Impedance modeling for SuperKEKB main ring (follow-up 1)

2023-01-17

Introduction

Model of Flange

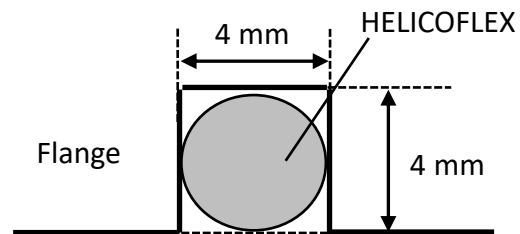
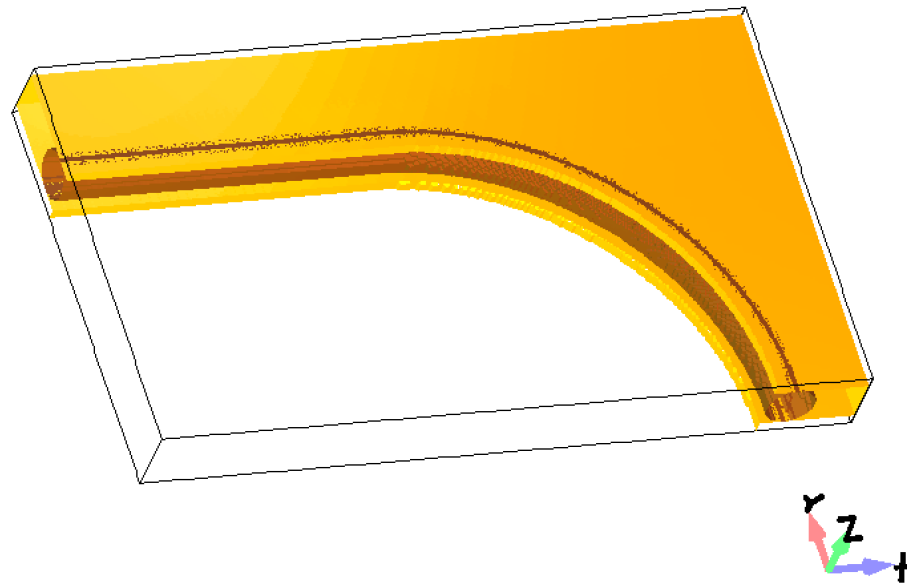
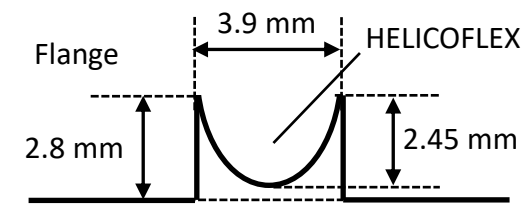
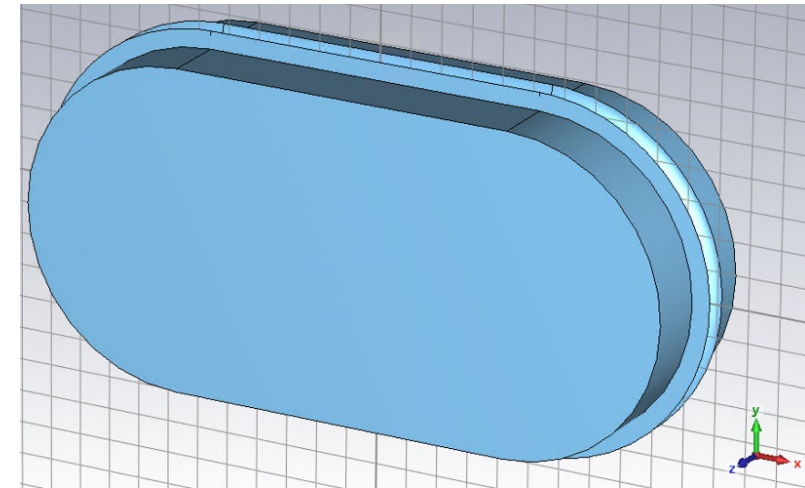
- D. Zhou pointed out that the wake of the flange in HER looks very resistive and unphysical. The wake of the flange more resistive than that of the RF-cavity.
- I checked, remodeled and recalculate the model of the flange.

- Old model (gdf_flange_220419) created by K. Shibata.
- New model (gdf_flange_230111) remodeled by me after D. Zhou pointed out.
